Docket Item # 13
BAR Case #2006-0008

BAR Meeting
February 15, 2006

ISSUE: Re-approval of addition and alterations

LOCATION: 217 North Saint Asaph Street

Figure 1 - Rear (east) elevation

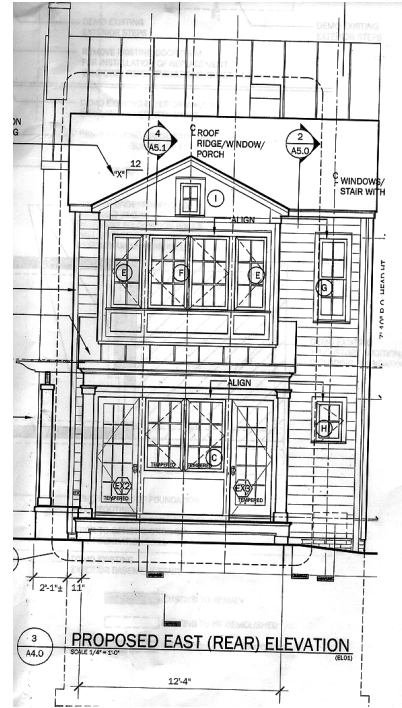
will be composed of wood windows with wood trimmed MDO panels below. The south side of the sunroom will have a pair of eight-light casement windows on each story. The sunroom section will cover the southernmost two thirds of the rear (east) elevation of the addition. The northern bay of the new addition will have a small four-light casement in the first story and a narrow four-over-four double hung window in the second story. The sunroom section will have multi-light doors on either end with a pair of nine-light casement windows between them and wood panel below. The second story of the sunroom section will have four casement windows ganged together. The outer two will be six-light will the center two will be nine-light. The north elevation of the addition will be clad in wood siding and will be blind. The sunroom section will have a pair of eight-light casement windows in the first story and a pair of six-light casement windows in the second story. A shed roof porch, the same width as the sunroom section will project from the rear wall of the addition and extend 2'4" beyond the sunroom. It will be supported on wood columns and will rest on a 1 1/2' high wood deck which will extend well beyond the porch into the back yard.

Figure 2 - South side elevation

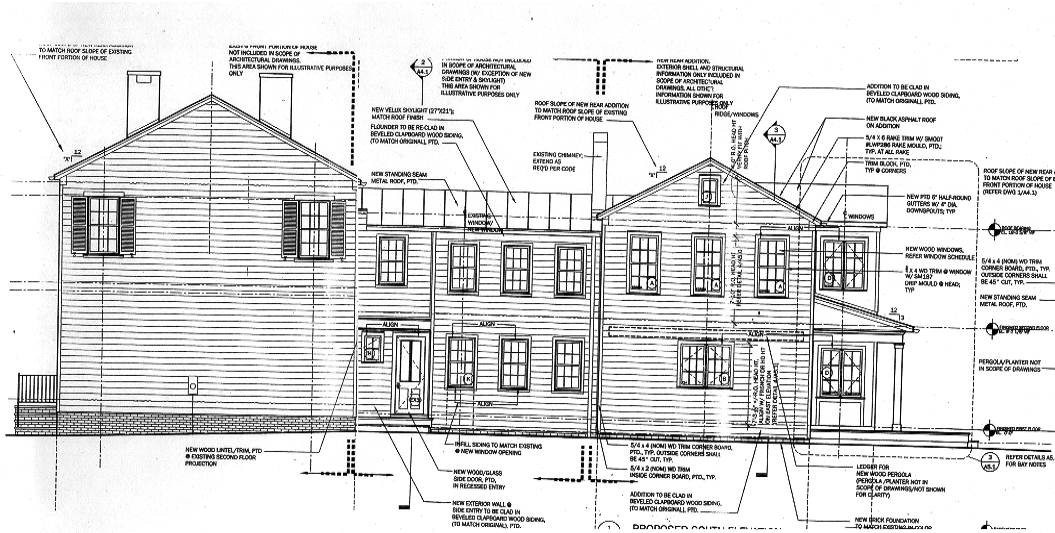
The south side elevation of the addition will have a pair of nine-light casement windows centered in the first story and three evenly spaced six-over-six double hung windows in the second story. There will be a small four-light window in the attic story. At the east end of the addition will be the two story sunroom section, projecting six feet beyond the end of the addition. The sunroom
